Access Compliance Report

Public Rights-of-Way

(Curb Ramps)

Intersection ID: 53181	Main Street: GOODMAN_PARK_CT	Cross Street: BASIE_PARK_CT	Location: NE
ADA ID: 52FD6D12B46F	Ramp Type: Perp	Initial Pass/Fail: Fail	Overall Compliance: No
		Severity Score: 10

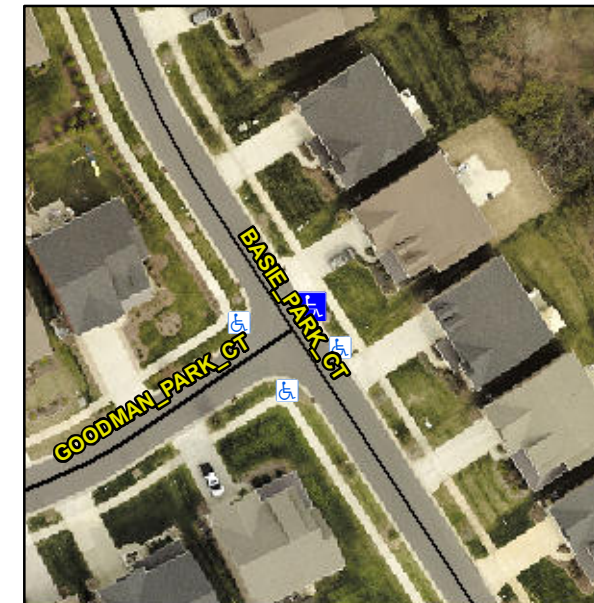
Not Found, R304.5.1

Compliance	Description	Data	Compliance	Description	Data
N/A	Ramp Length (in)	94.0	Yes	Ramp Slope (%)	6.3
No	Ramp Width (in)	47.0	Yes	Ramp XSlope (%)	3.0
N/A	Flare Type LT	N/A	N/A	Flare Type RT	N/A
N/A	Flare Slope LT (%)	N/A	N/A	Flare Slope RT (%)	N/A
N/A	Flare Traversable LT?	N/A	N/A	Flare Traversable RT?	N/A
N/A	Landing Length (in)	N/A	N/A	DWS Provided?	N/A
N/A	Landing Width (in)	N/A	N/A	DWS Contrast?	N/A
N/A	Landing Slope (%)	N/A	N/A	DWS Length (in)	N/A
N/A	Landing X Slope (%)	N/A	N/A	DWS Full Width?	N/A
N/A	Landing Curb? (Y/N)	N/A	N/A	DWS Offset (in)	N/A
N/A	Shared Landing?	N/A			
N/A	Gutter Ponding?	N/A	N/A	Gutter Slope (%)	N/A
N/A	Gutter Lip Ht (in)	N/A	N/A	Gutter X Slope (%)	N/A
N/A	Painted X Walk1?	No	N/A	Painted X Walk2?	N/A
	X Walk 1 Direction	To W		X Walk 2 Direction	N/A
N/A	X Walk 1 Width (in)	N/A	N/A	X Walk 2 Width (in)	N/A
	X Walk 1 Slope (%)	6.0		X Walk 2 Slope (%)	N/A
	X Walk 1 X Slope (%)	4.1		X Walk 2 X Slope (%)	N/A

Remove & Replace Entire Ramp.
